TENNESSEE VALLEY AUTHORITY

In the Matter of the Applications of) Docket Nos. 50-390
Tennessee Valley Authority) 50-391

In telephone conversation with TVA representatives on November 10, 1972, Messrs. Paul Check and Mark Peranich of AEC requested additional information on TVA's Quality Assurance Program for Design and Construction. The needed clarification was obtained by specific questions, which are set forth below with TVA's response.

ORGANIZATION CHART FOR OEDC QUALITY ASSURANCE STAFF

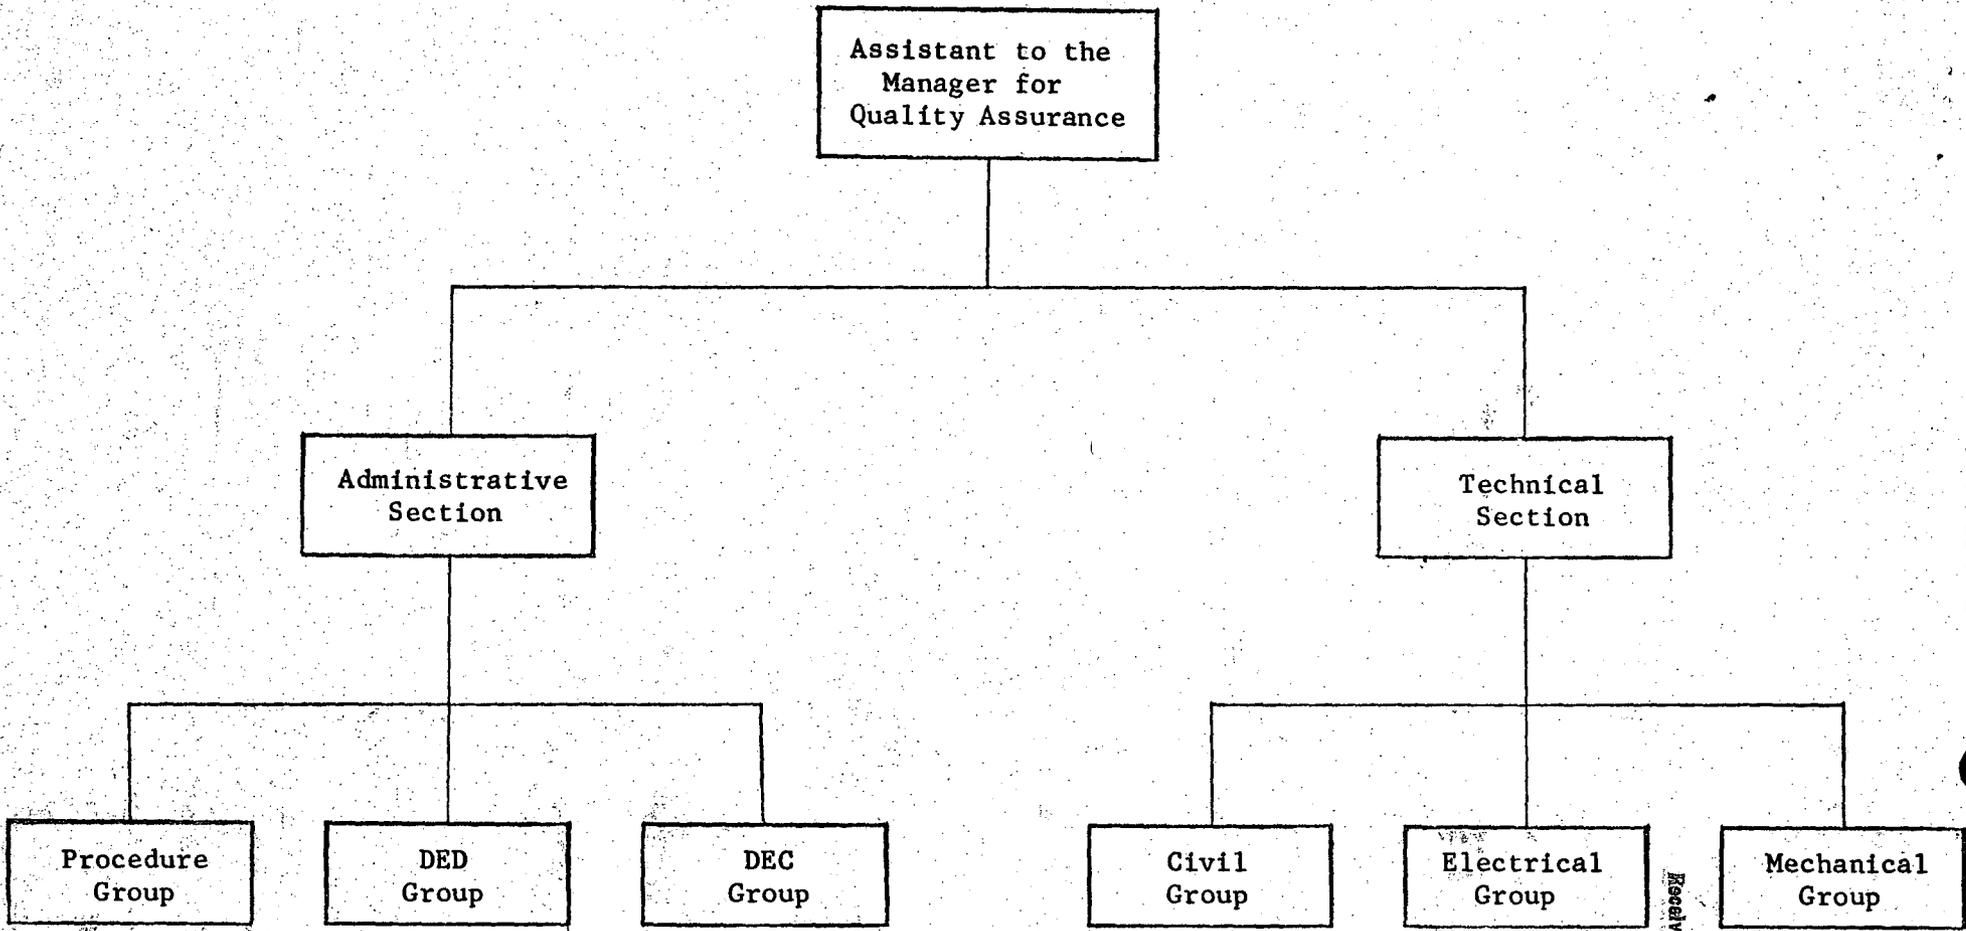
- a. Illustrate on a separate organizational chart the referenced QA staff which is supervised or directed by the assistant to the manager for quality assurance. Discuss the functional assignments and full-time or part-time aspects of each staff position.
- b. With respect to audits of the Division of Engineering and Construction to what extent will such audits examine procedures, activities, and records? Who will perform these audits? What qualifications will be specified for auditors? What will be the frequency of audits? Also, discuss which audits will include independent, selective examinations of the end product developed or constructed by each organization.

- a. Enclosure 2 is an organizational chart for the OEDC Quality Assurance Staff supervised by the Assistant to the Manager for Quality Assurance. The composition and functional assignments will be as follows:

Administrative Section--This section will be composed of a Procedure Group, a Division of Engineering Group, and a Division of Construction Group. It will be responsible for auditing the activities of the Divisions of Engineering Design and Construction for compliance with Quality Assurance Procedures and Administrative Releases dealing with QA. It will also assure through audits that procedures are available to cover quality assurance activities before the actual performance of the activities.

Technical Section--This section will be composed of the Civil Engineering Group, the Electrical Engineering Group, and the Mechanical Engineering Group. It will be responsible for auditing site activities for compliance with Construction Procedures in areas such as welding, concreting, calibrating, and nondestructive testing. This section will also be responsible for auditing the quality assurance aspects of the preoperational test program. In addition to the full-time staff personnel, the specialized expertise available in other organizational elements of OEDC will be utilized when and as necessary for auditing specific activities. These audit activities will be outside and independent of their normal assignments.
